Access Compliance Report Public Rights-of-Way (Curb Ramps)

Main Street: DEAN_ST Cross Street: RAINBOW_DR Location: NW

ADA ID: RPRK211014152534 Ramp Type: Type 1 - Perpendicular Diagonal Initial Pass/Fail: Fail Overall Compliance: No Severity Score: 15

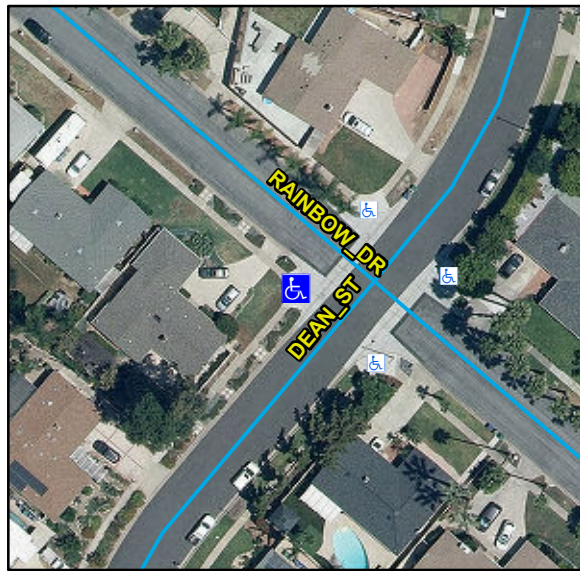
R304.2.2, STD 1115

Remove & Replace Curb Ramp With Two New Directional Ramps or Equivalent.
